DOCKET NO.: HITACHI-0019

Serial No.: 09/894,017

Response to Office Action dated March 25, 2004

Annotated Version

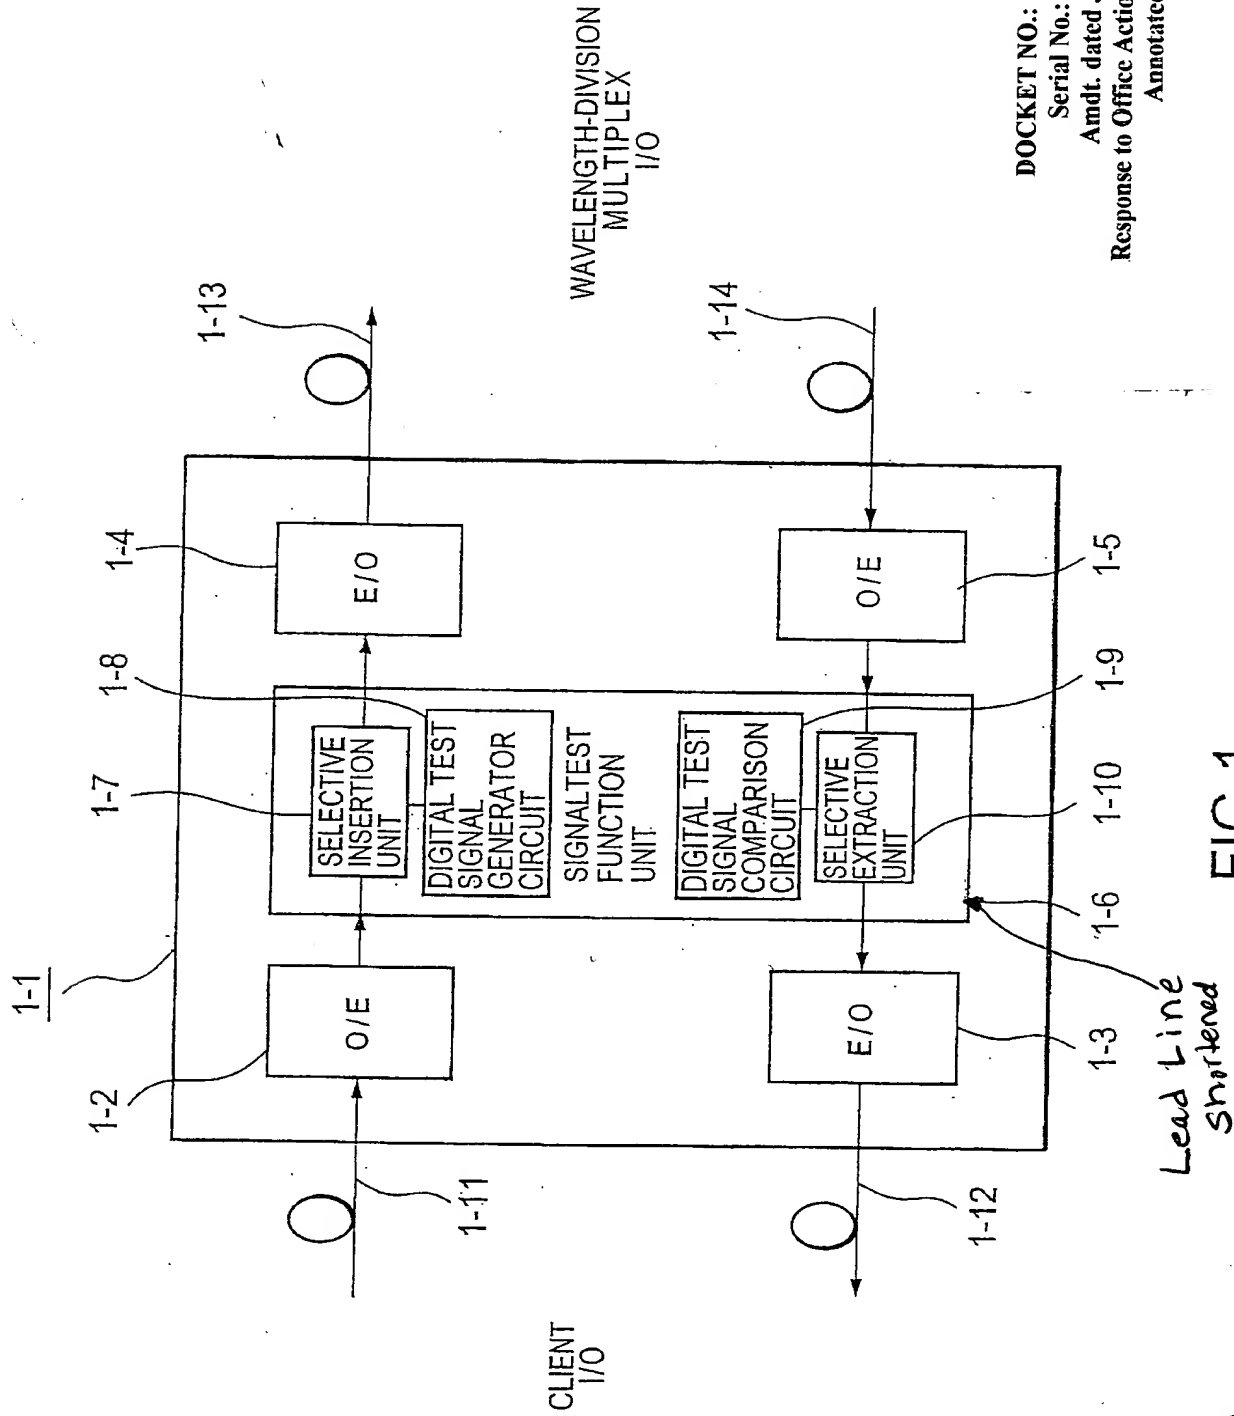
Figures 1, 3, 5, and 6 have been amended to clarify features of the drawings and to correct minor errors in labeling.

Figures 1 and 3 were amended to correct a lead line as to where reference numeral "1-6" and or "1-9" should point. Support for the amendment of Figure 1 can be found on page 7, lines 10-19 of the Applicant's Specification. Support for the amendment of Figure 3 can be found on page 9, lines 4-5 of the Applicant's Specification. Figure 5 was amended to correct a lead line as to where the reference numeral "1-10" pointed. Support for this amendment can be found on page 12, line 15 of the Applicant's Specification. Figure 6 has been amended to correct a mislabeling and to correctly label features of the drawing. Support for these amendments can be found on page 14, lines 13-18 and page 15, line 1 of the Applicant's Specification. No new matter has been added to the Drawings.

FIG.6

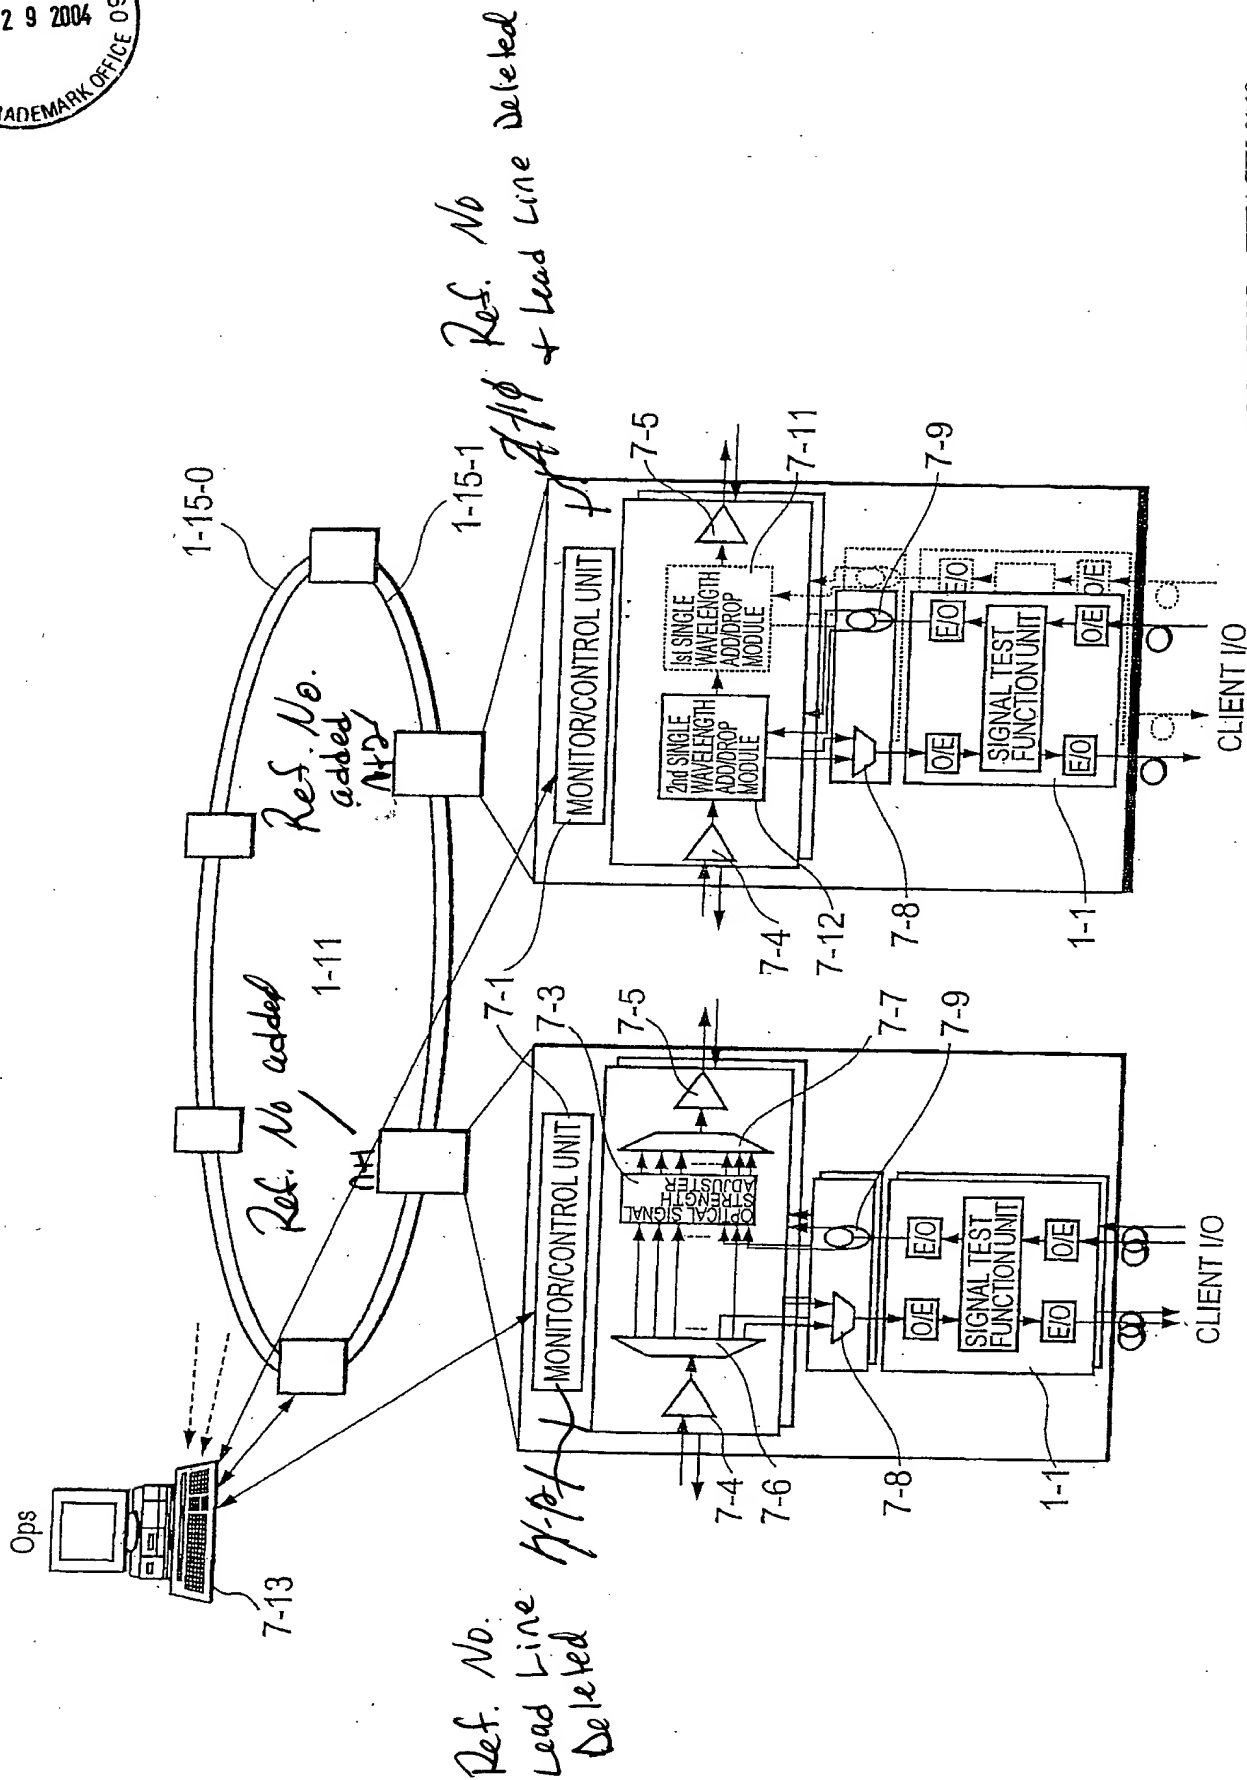
The Examiner rejected claim 21 because, “the applicant does not disclose the claimed optical selector that separates wavelengths.” The Office Action indicates that “the applicant discloses wavelengths being separated by a demultiplexer (fig. 6, element 7-6) or add/drop module (fig. 6, element 7-12) and then sent to an optical selector (fig. 6, element 7-8) that selects between already separated wavelengths.” The Applicant has amended claim 21 by changing the word “selector” to “demultiplexer.” As noted in the Office Action, the demultiplexer separates wavelengths and therefore acts as a optical wavelength separator. The Applicant respectfully submits that newly amended claim 21 overcomes the rejection under 35 U.S.C. §112, First Paragraph and requests that the rejection be removed.
